## NEW STYLE LATCH FOR GEN 3 LIQUID LEVEL CONTROLLER

This product notice is to inform you that we have redesigned the latch for the Gen 3 Pneumatic Liquid Level Controller.

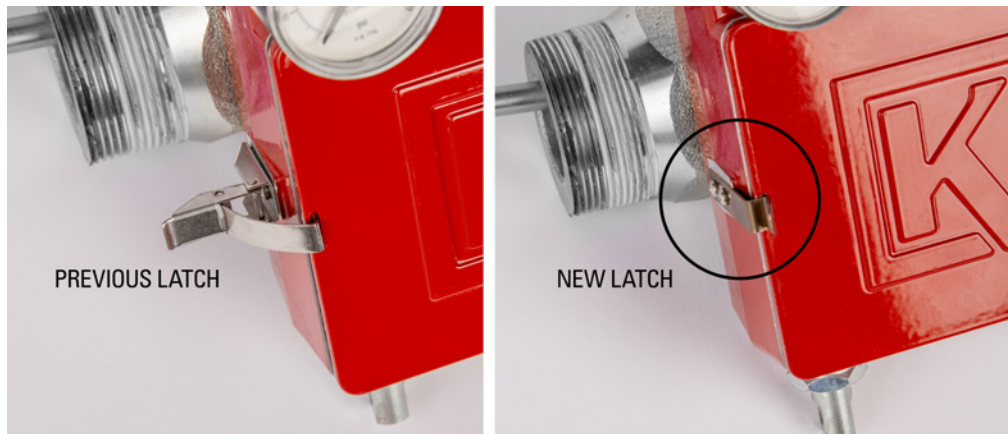
The new latch is easier to close and release and features a much lower profile for better fit in tight spaces, as encountered with some flange and hammer union connections.

As of 3/10/2025, all new Gen 3s produced will have the new latch installed, beginning with Serial Number **2250770001**.

The new latch is compatible with all existing Gen 3 enclosures. While replacement is not required, if you want to replace the original latch on your controller, simply remove the two existing screws and use them to fasten on the new latch.

**New latch part number: 7947**

**Screw part number: 7752 (2 per latch)**
